To: Development Permit Panel
From: Jean Lamontagne
Director of Development
Date: August 2, 2006
File: DP 05-320225
Re: **Application by Sungrand Developments Ltd. for a Development Permit at
11651, 11671, 11691, 11711 Steveston Highway**

Excerpt from the Minutes from
The Design Panel Meeting

Tomizo Yamamoto, Architect
11651/11671/11691/11711 Steveston Highway
(Formal)

DP 05-320225

ATTACHMENT 3

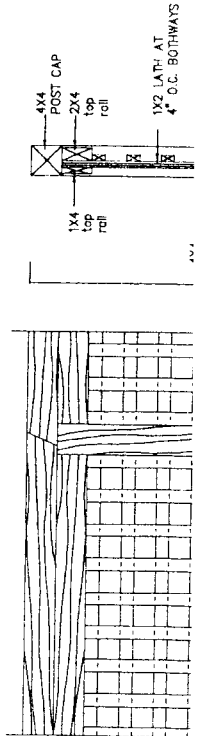
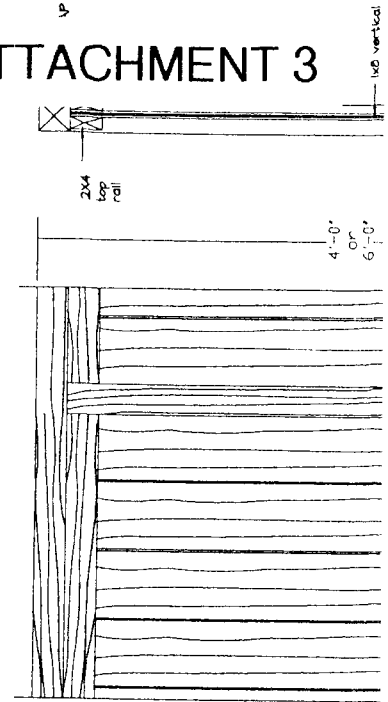
- A berm (**Attachment 3**) will be introduced along Steveston Highway in accordance with the Ironwood Sub-Area Plan, which will improve noise attenuation and spatial separation from Steveston Highway.

- A 1.2 metres (4 ft.) high landscape buffer planted with Satomi Korean Dogwoods and a mixture of Cedars and Azaleas will be established along Steveston Highway as required by the Ironwood Sub-Area Plan (**Attachment 3**).
